ATHENS FULL SERVICE MAINTENANCE FACILITY

OHIO DEPARTMENT OF TRANSPORTATION

TMCC AS-BUILTS
[FIELD SET]

THOMAS & MARKER CONSTRUCTION

PV201

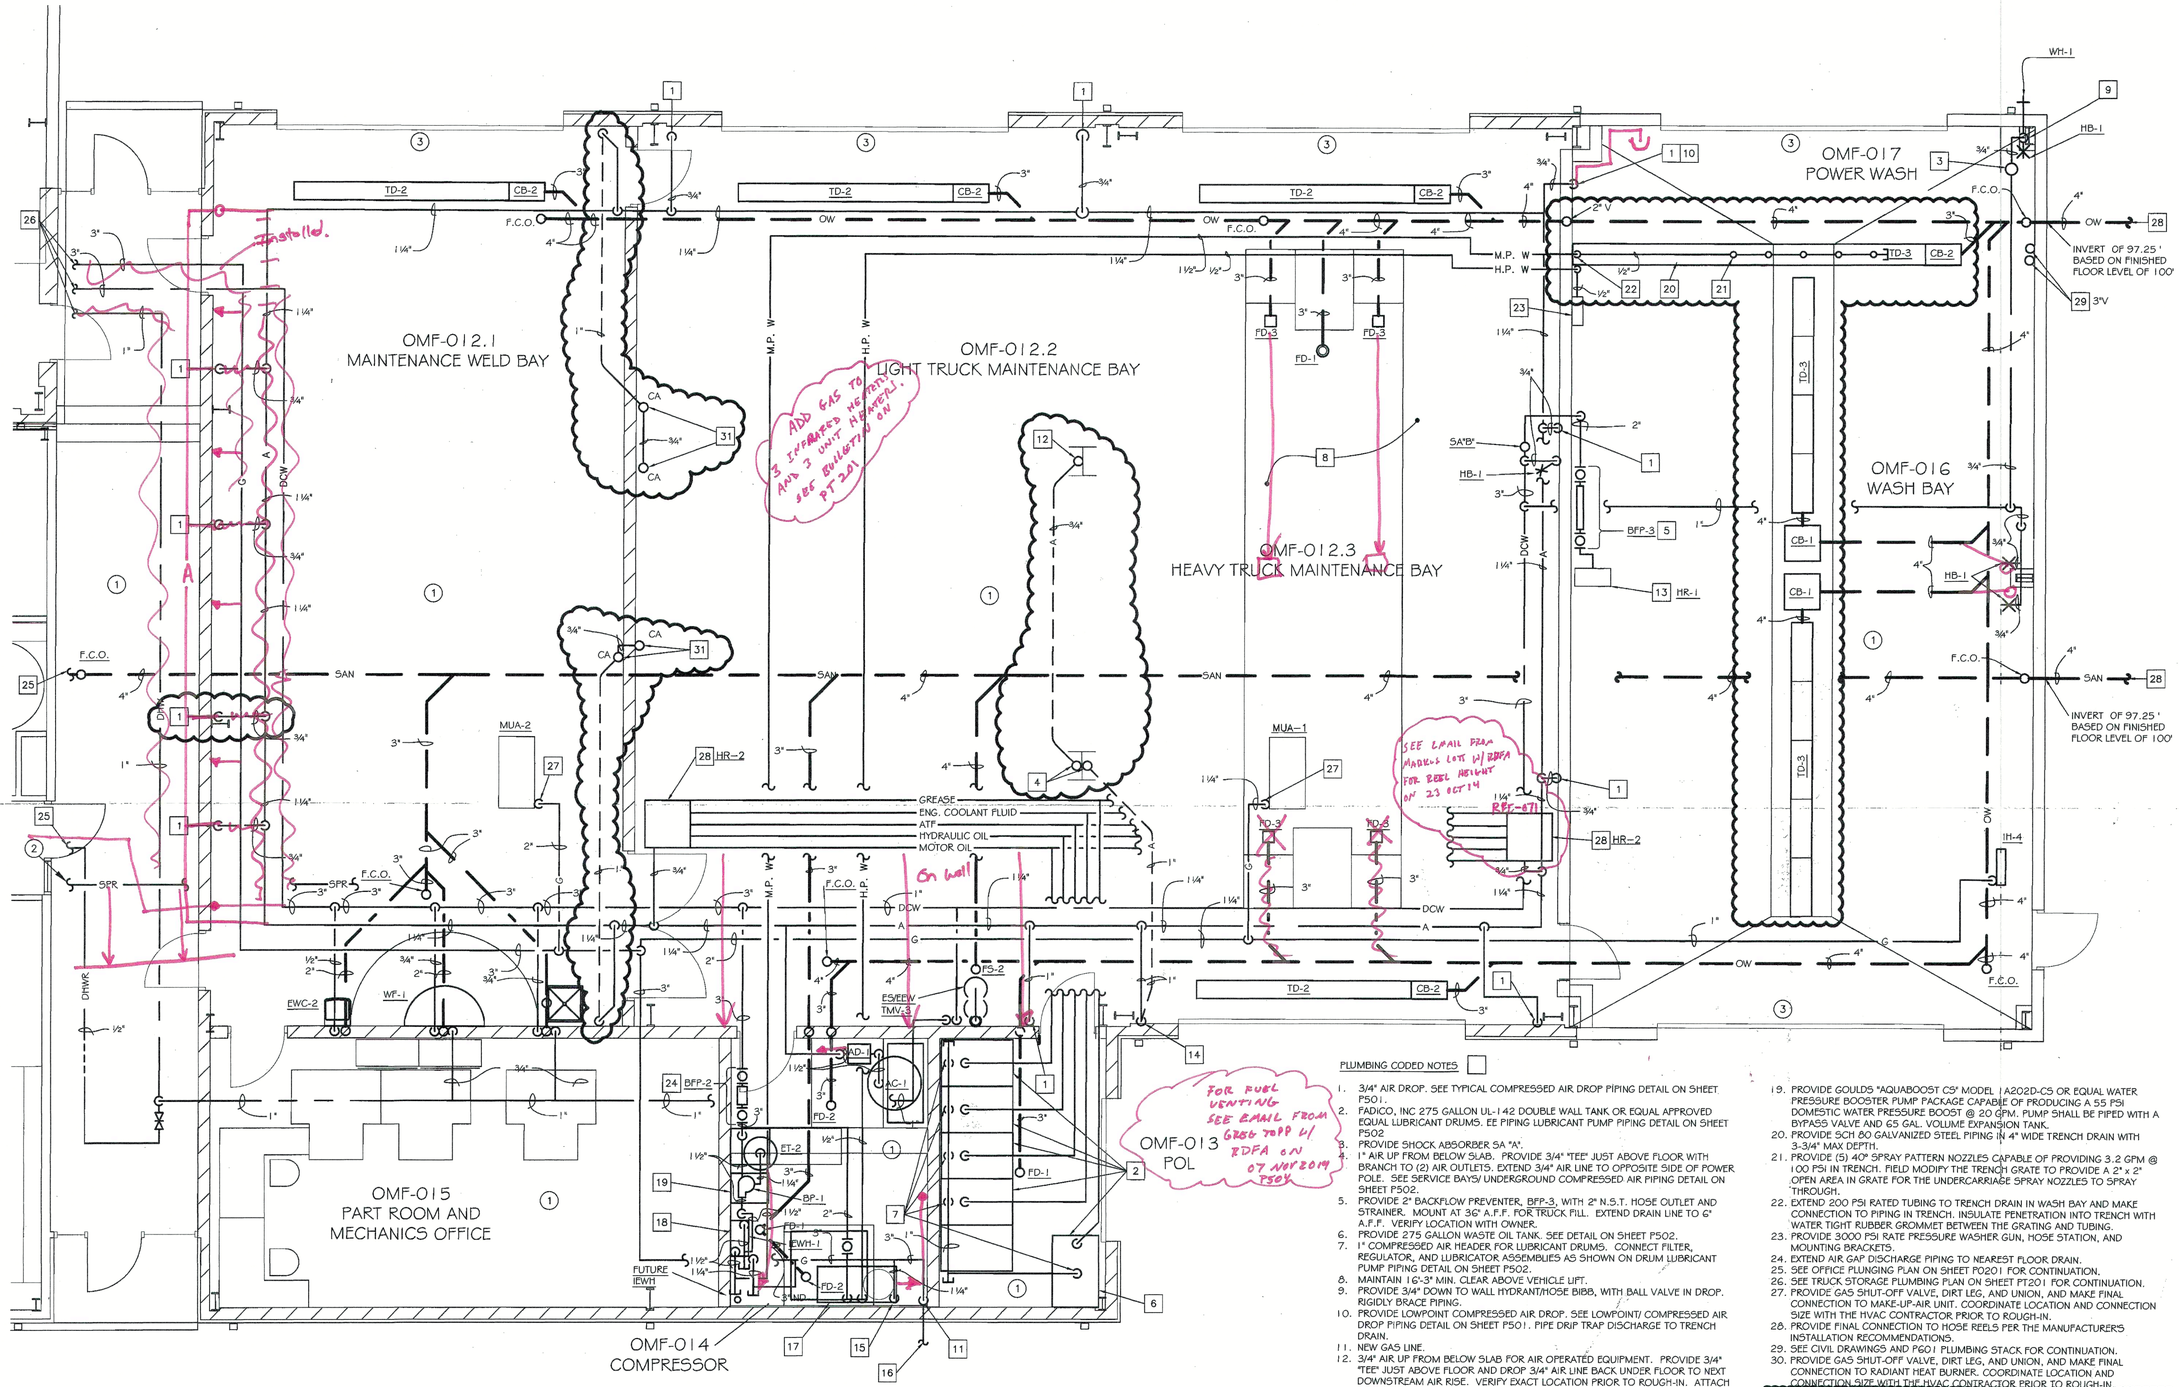
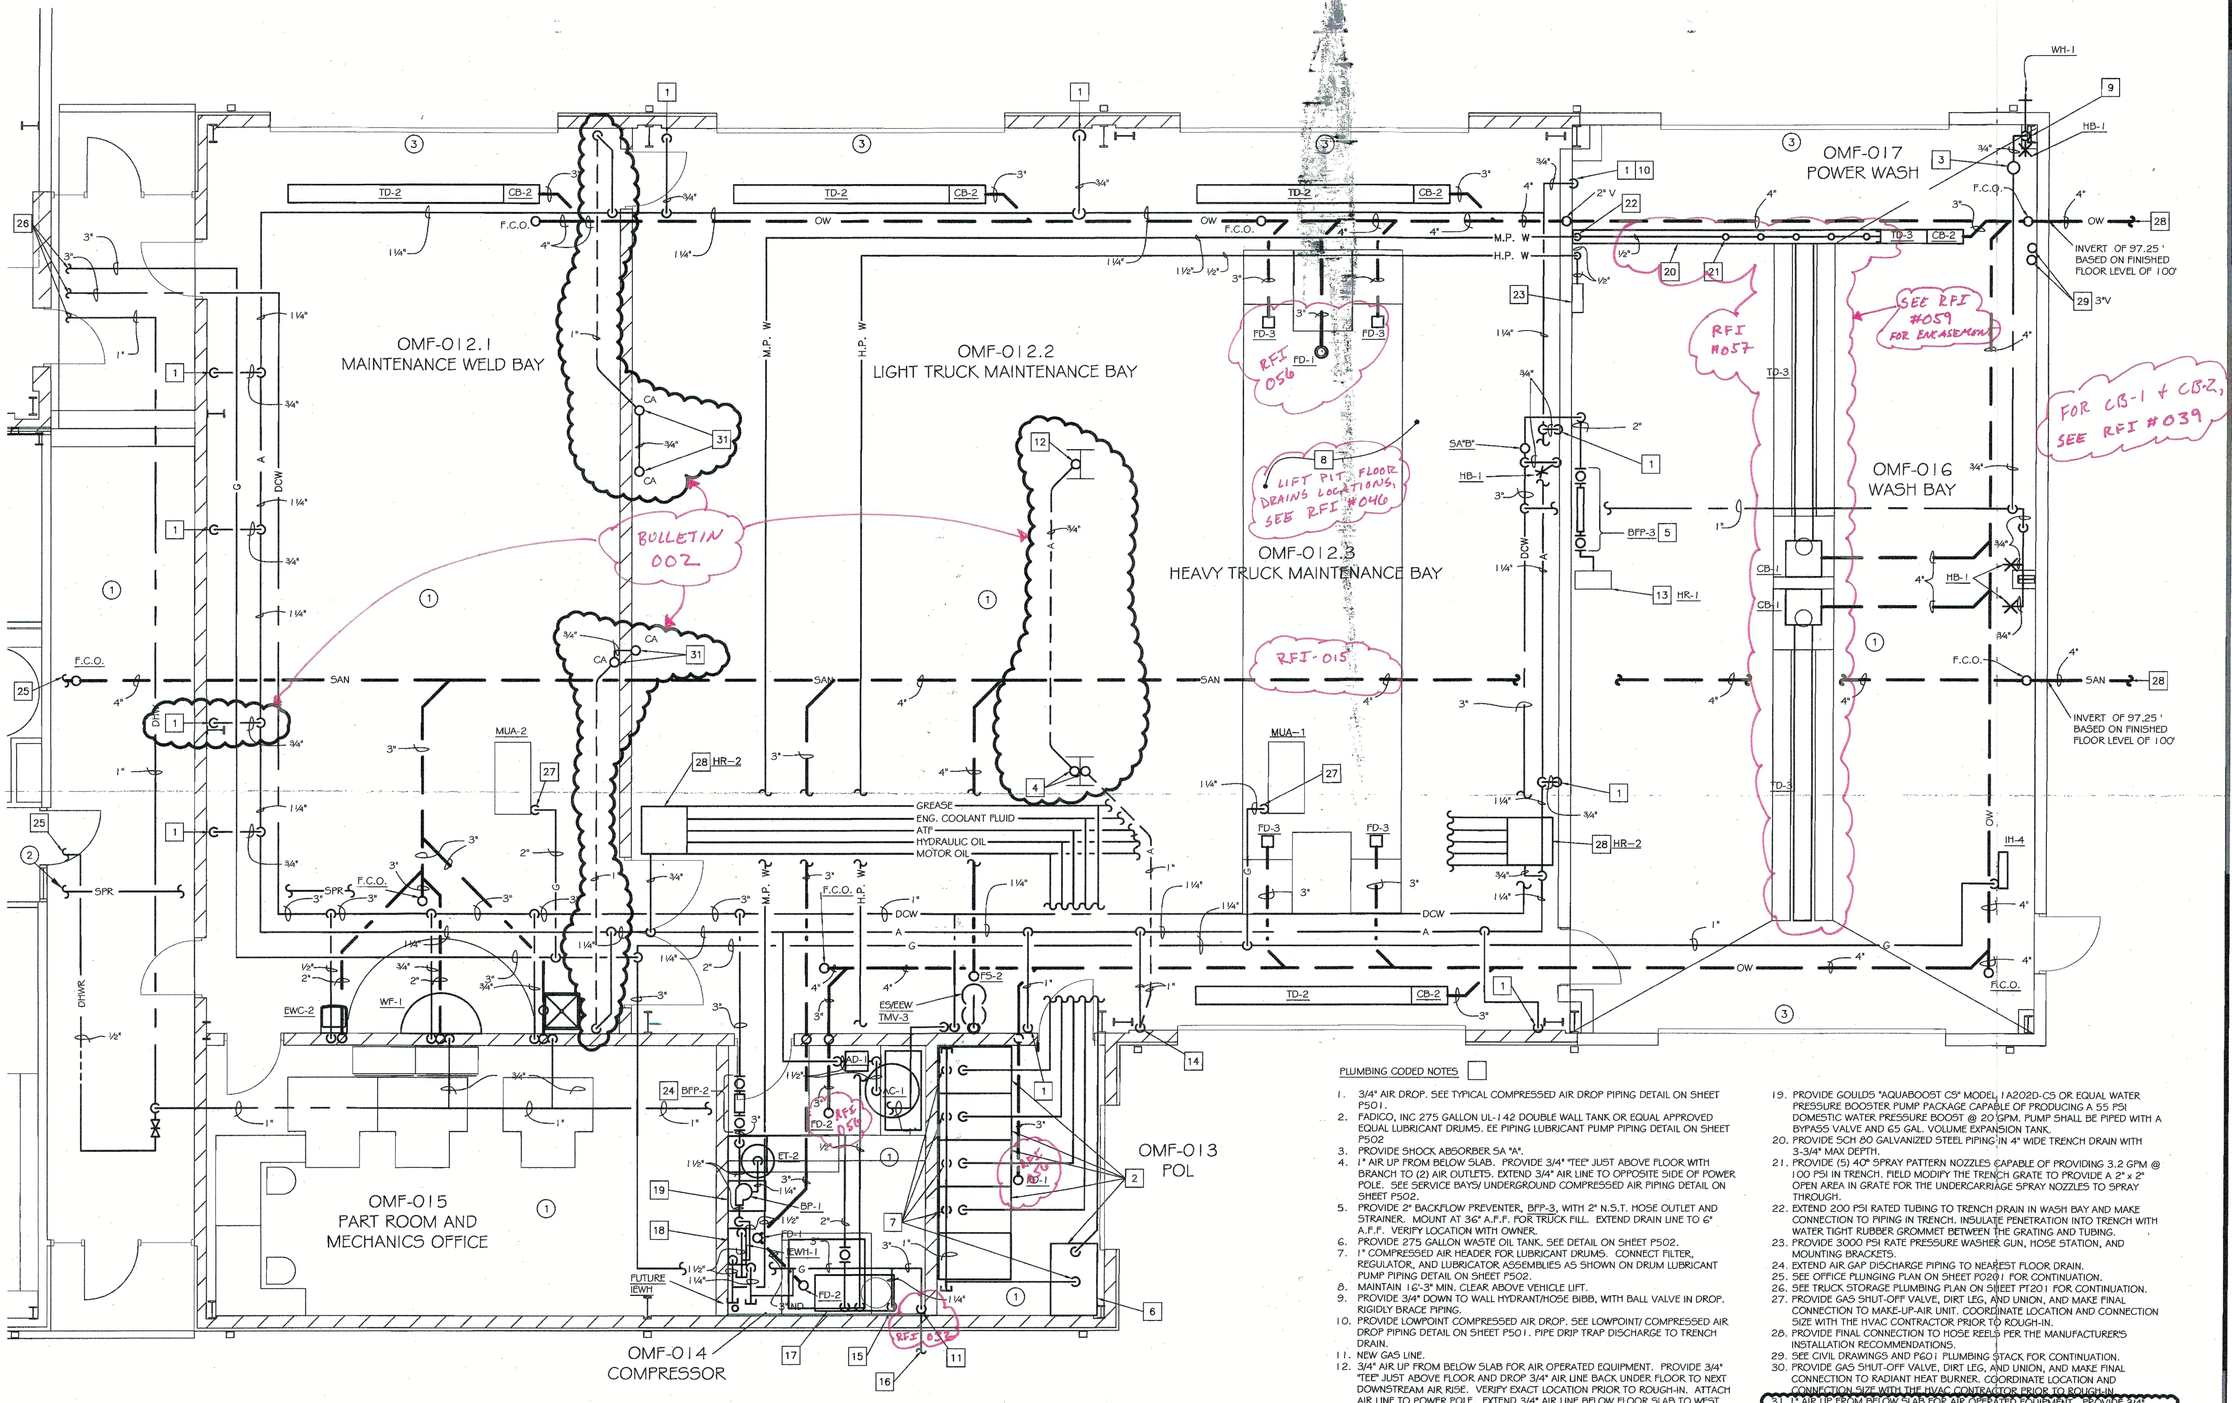
Please reference sheet PV201

THE CONTRACTOR SHALL LOWER BOTH LINES TO 96.25 AS PER HIS RECOMMENDED ACTION. THIS CHANGE SHALL BE COORDINATED WITH THE SITE UTILITY CONTRACTOR AS IT MAY IMPACT THEIR SITE SANITARY ELEVATIONS.

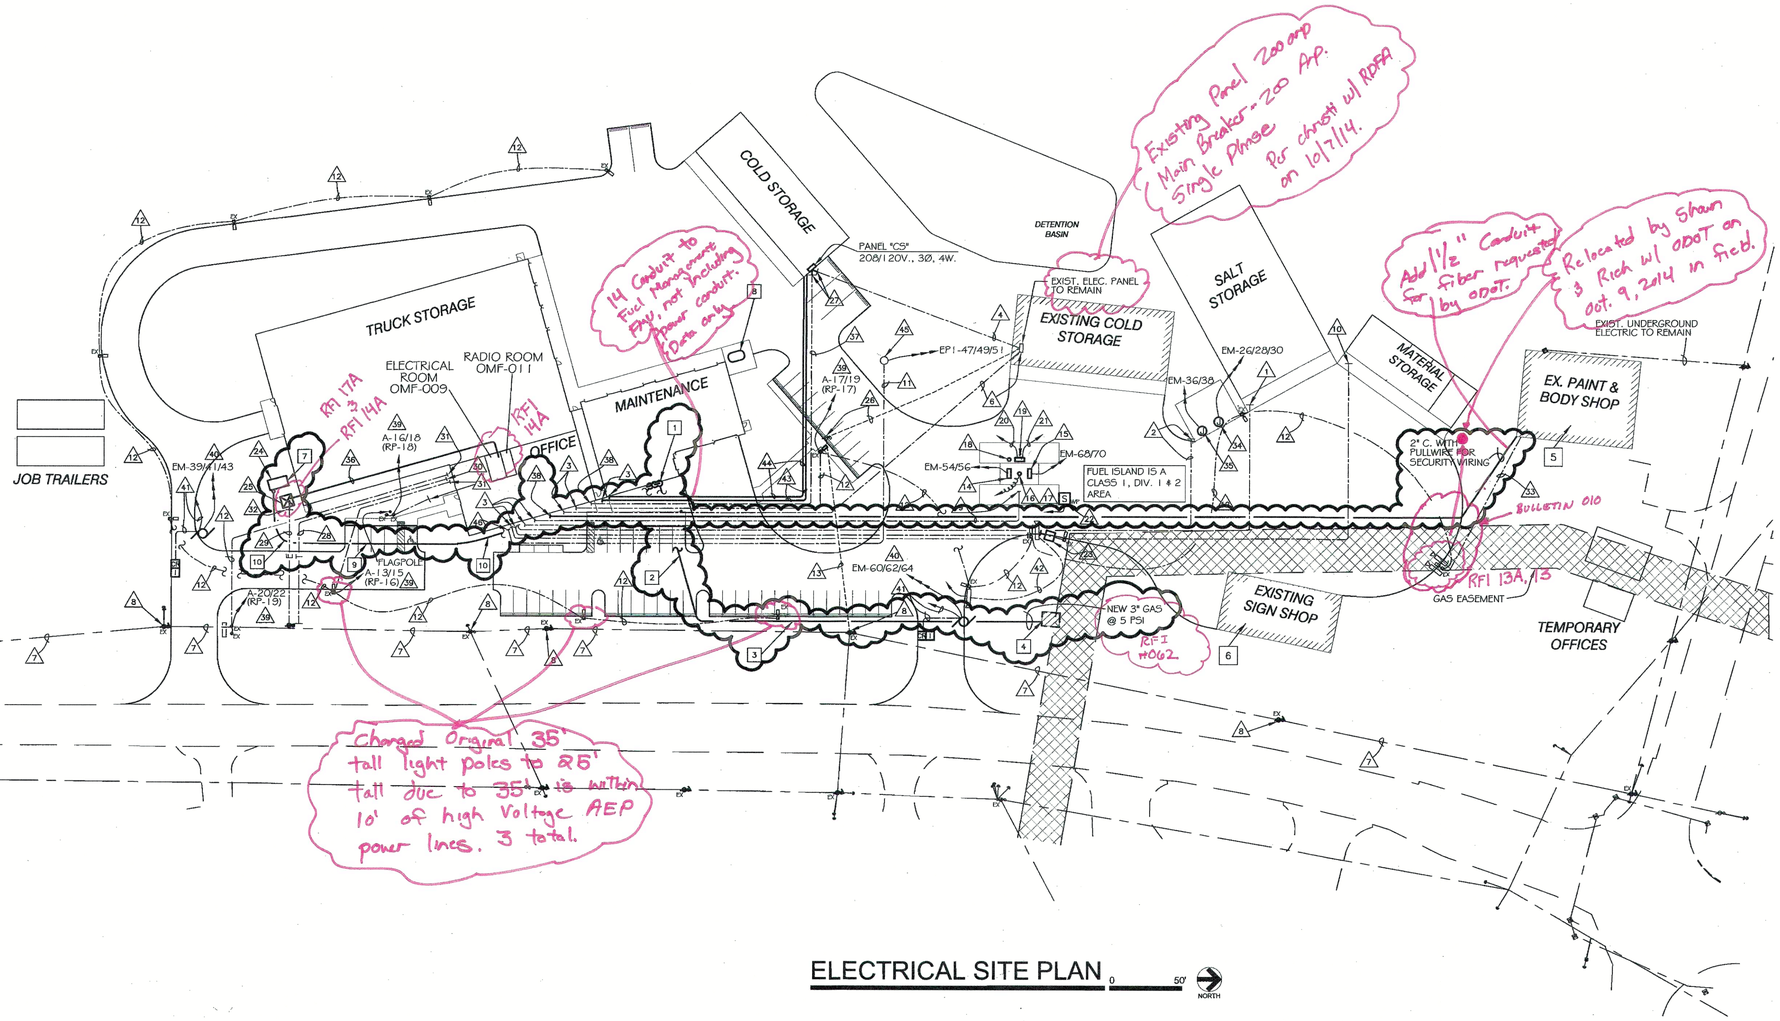
Please advise

REPLY (RETURN THIS SHEET WITH REPLY):
At 4' deep the conduits will be running under the wall footers. Refer to detail on sheet S001 for structural requirements to run conduits under footers.
